LINCOLN CITY/LANCASTER COUNTY PLANNING STAFF REPORT

P.A.S.#: County Change of Zone #211
The Preserve at Cross Creek Pre. Plat #02029

Date: January 22, 2003

PROPOSAL: Brian D. Carstens, for Land II L.L.C., has requested a Change of Zone and Preliminary Plat to create 15 lots on property generally located at S. 68th and Roca Rd.

County Preliminary Plat #02029
County Change of Zone #211
The Preserve at Cross Creek
S. 68th & Roca Rd.

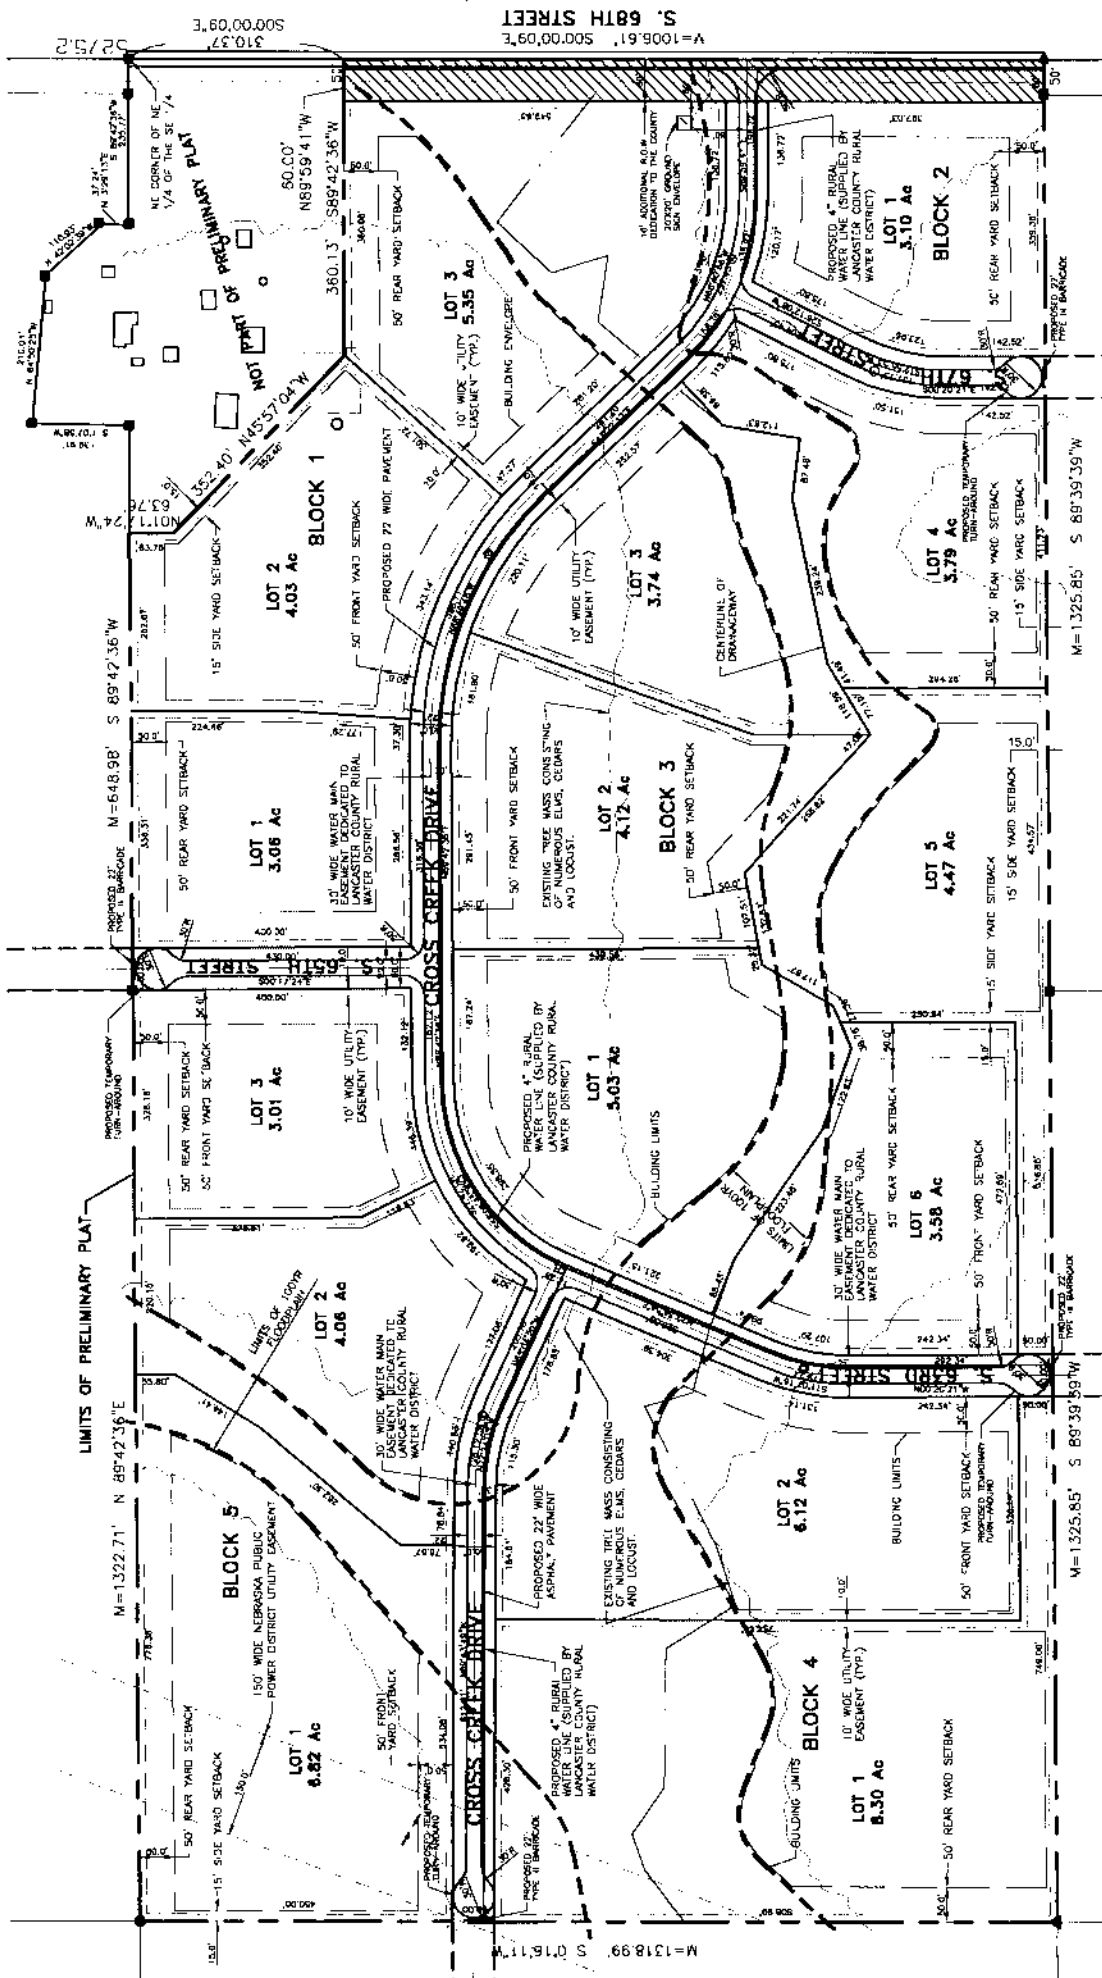
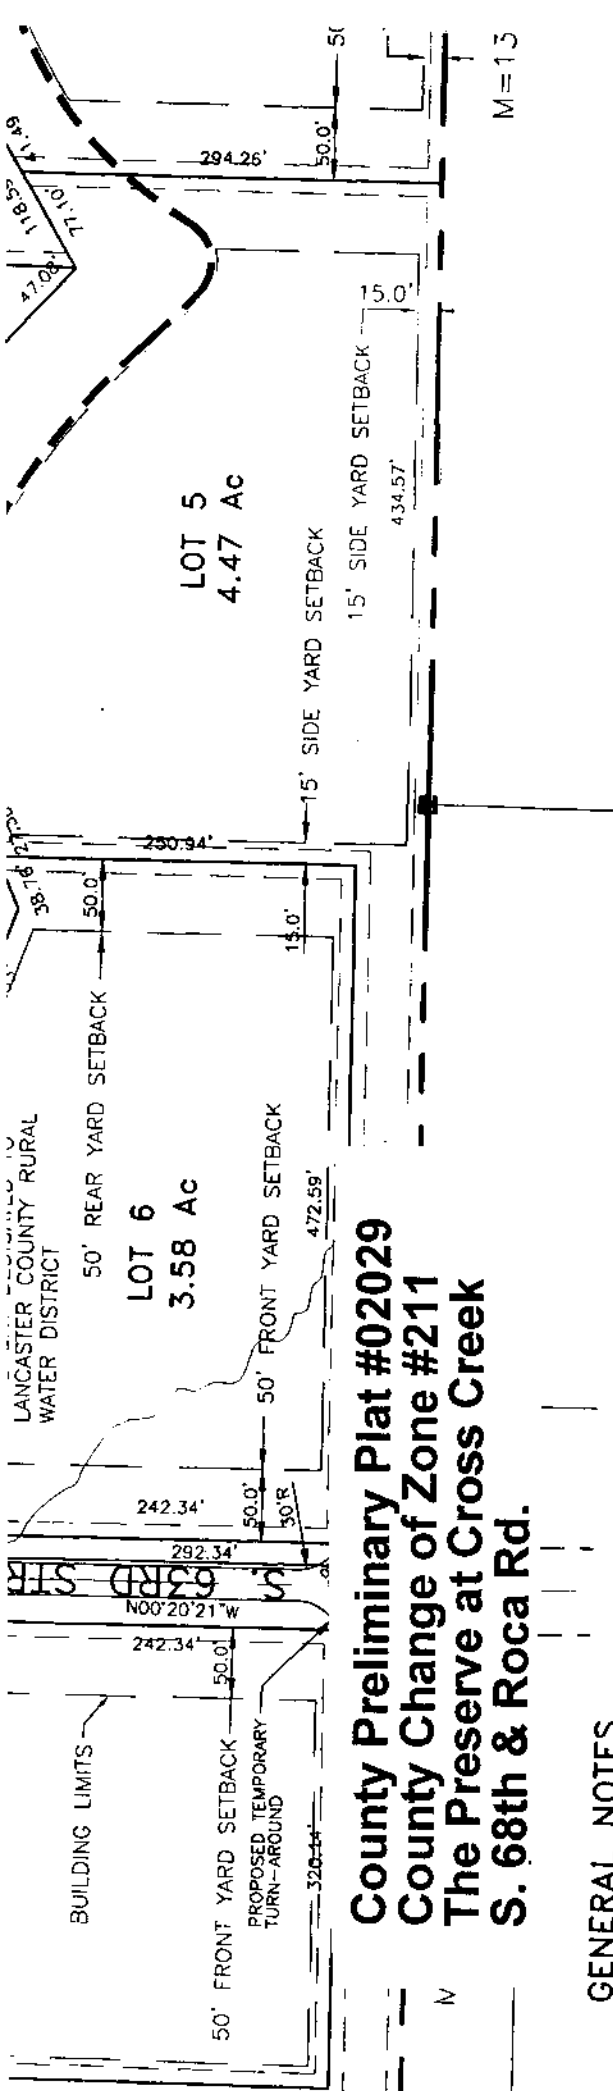
8. The area in the northeast corner of the drawings labeled "Not Part of Preliminary Plat" must be included since this area is part of the property being subdivided.

9. The plat should not include the existing 50' of right-of-way along South 68th Street. The legal description needs correction.
10. The following flood plain issues need to be resolved:

- A. The flood plain shown on the FEMA maps does not match what is shown on these drawings.
 - B. The minimum building opening elevation on some lots is lower than the 100 year flood elevation - See Lot 5, Block 3.

11. No culvert design information is provided.
12. A culvert permit is needed at the intersection of South 65th Street and Cross Creek Road.
13. No drainage area information is provided for the 24" culvert at South 67th Street and Cross Creek Road.

1. Proposed Lot 5, Block 3, does not meet minimum frontage requirements for the proposed AGR district. I am not aware how a requested waiver related to the prelim plat can modify this minimum height and area regulation of the AGR district.

1.3.1 Rename Cross Creek Drive.

1.3.2 Revise the frontage of Lot 5 Block 3 to 175' or more.

1.3.6 Remove notes #4 and 5, this is not a CUP.
